1 Products affected

2 Type of change

Product Change Notification					PCN 6610 - Change of Material		
owner	creation date	release date	released by	change order no	rev	page	D10-033-108
vettessa	19.05.2020	19.05.2020	wuillsco	2015290	B	1 of 2

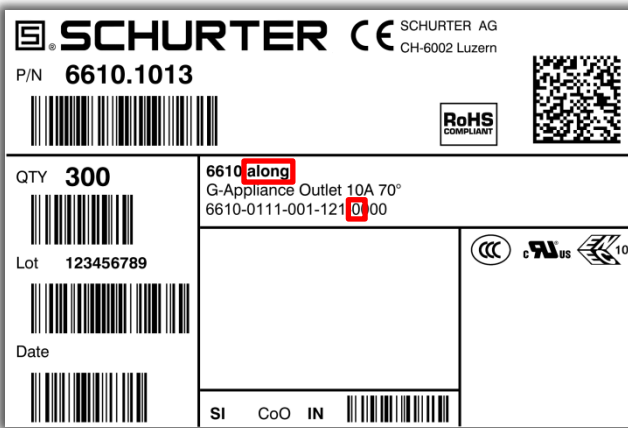
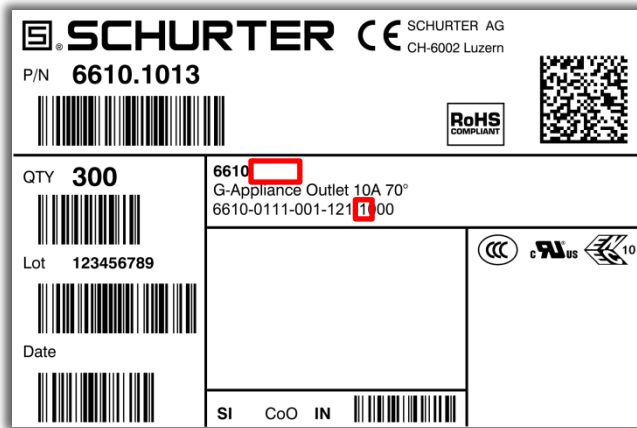
Old material	New material
Polyamid PA6 (GWIT standard / V0) Polyamid PA66 (GWIT standard / V2)	Polyamid PA6 (GWIT enhanced / V0)
Old packaging label	New packaging label
 (6610-0XXX-XXX-XX1-0XXX)	 (6610-0XXX-XXX-XX1-1XXX)

- Enhanced glow wire requirements
- Material consolidation
- Appearance consolidation (colour of the front surface according to 4710-5)
- Configuration code changed because of enhanced glow wire requirements.

Orders placed after WW20/20 are manufactured with the new material. The change is traceable on the label by the printed configuration code.

Form	Yes	Appearance of colour
Fit	No	-
Function	No	-
Manufacturing	No	-
Label	Yes	Configuration Code changed
Packaging	No	-
